RENESAS TECHNICAL UPDATE

Product Category	MPU/MCU		Document No.	TN-RX*-A188A/E	Rev.	1.00
Title	Corrections to Descriptions for the P/E Suspend Command of Flash Memory in RX210 Group, RX21A Group, and RX220 Group		Information Category	Technical Notification		
Applicable Product	RX210 Group, RX21A Group, RX220 Group	Lot No.	Reference Document	RX210 Group User's Manual: Hardware Rev.1.50 (R01UH0037EJ0150) RX21A Group User's Manual: Hardware Rev.1.10 (R01UH0251EJ0110) RX220 Group User's Manual: Hardware Rev.1.10 (R01UH0292EJ0110)		
		All

This document describes corrections to the descriptions for the SUSRDY bit and the flow chart of the P/E suspend command in the "ROM (Flash Memory for Code Storage)" section of User's Manual: Hardware for the applicable products mentioned above.

Figure 40.18 Procedure for Programming/Erasure Suspension

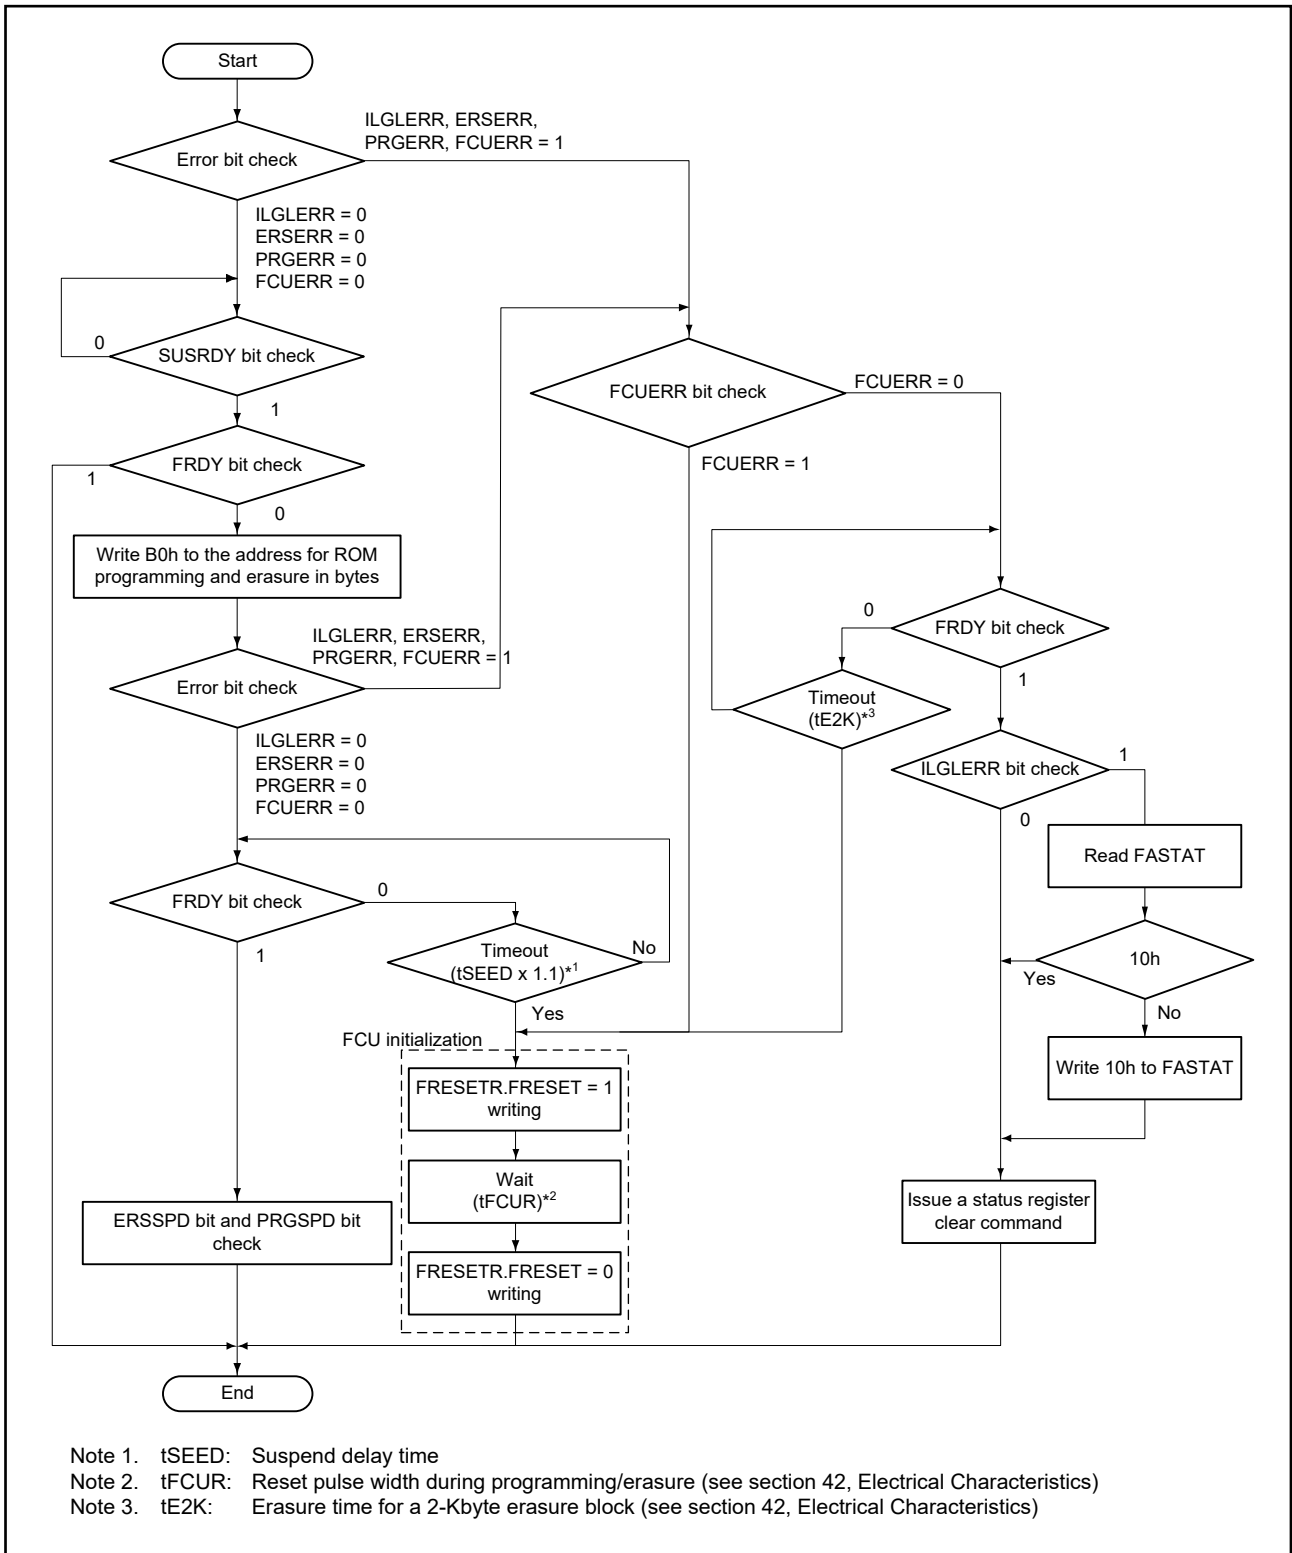
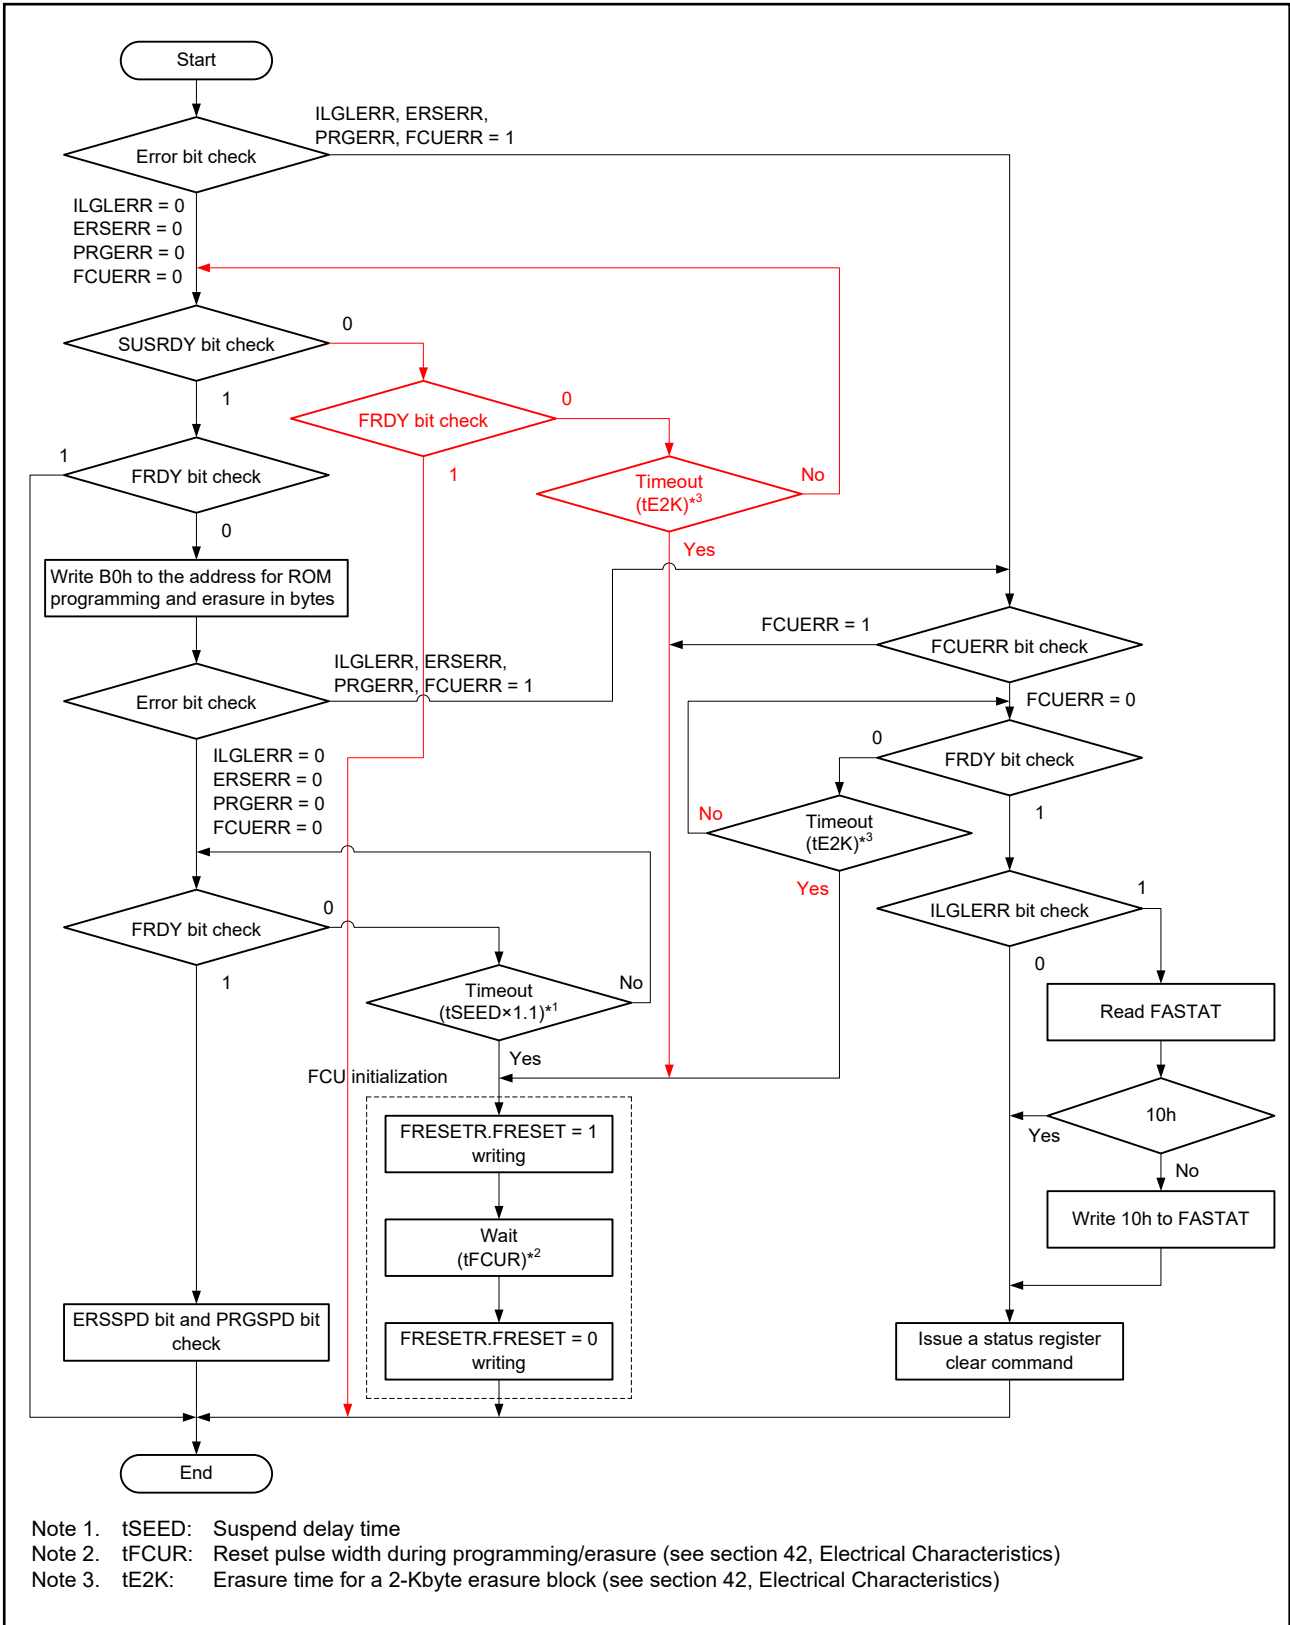
In Figure 40.18, Procedure for Programming/Erasure Suspension, a processing flow never escapes from the loop for a checking procedure if the programming/erasure processing completed before checking the SUSRDY bit.

Therefore, a timeout processing and a breaking processing when the FRDY bit is 1 are to be added.

Note 1. t_{SEED} : Suspend delay time
 Note 2. t_{FCUR} : Reset pulse width during programming/erasure (see section 42, Electrical Characteristics)
 Note 3. t_{E2K} : Erasure time for a 2-Kbyte erasure block (see section 42, Electrical Characteristics)
